STAFF REPORT: FEBRUARY 8, 2023 REGULAR MEETING

APPLICATION NUMBER: 23-8202

ADDRESS: 15015 ASHTON

SCOPE: INSTALL VINYL WINDOWS

Left: East elevation; 1 vinyl window, 5 wood windows proposed for replacement, 3 wood windows proposed to remain (photo by staff). Right: South elevation; 16 vinyl windows, 1 wood window proposed for replacement (photo from application, note that not all windows are visible.)

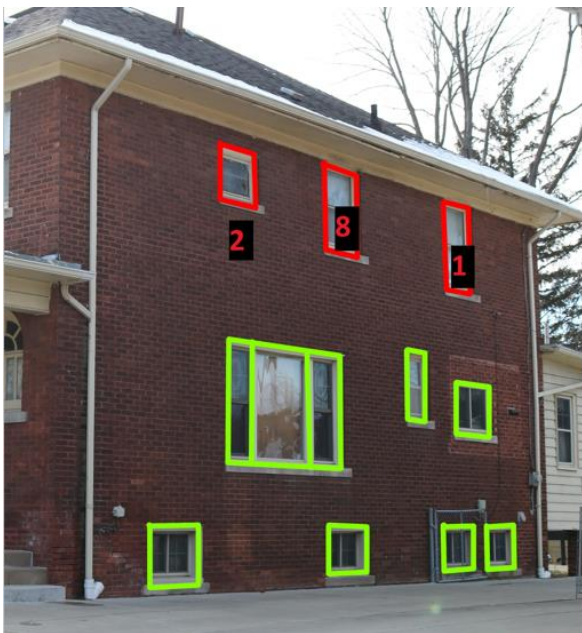
Shown below are photos marked by staff to indicate the proposed scope. Windows marked in red and numbered are proposed for replacement, windows marked in green and not numbered have already been replaced; windows not marked are not proposed for replacement.

- The windows proposed for replacement on the front (east) façade are unambiguously character-defining as they are subdivided, as described in the Elements of Design; further, their vertical muntin pattern imparts a Craftsman style to the house and provides a visual cue to the era of the building’s construction.

- The original windows on the north and south facades, though less clearly distinctive, are important to the character of their house due to their materials and operation.
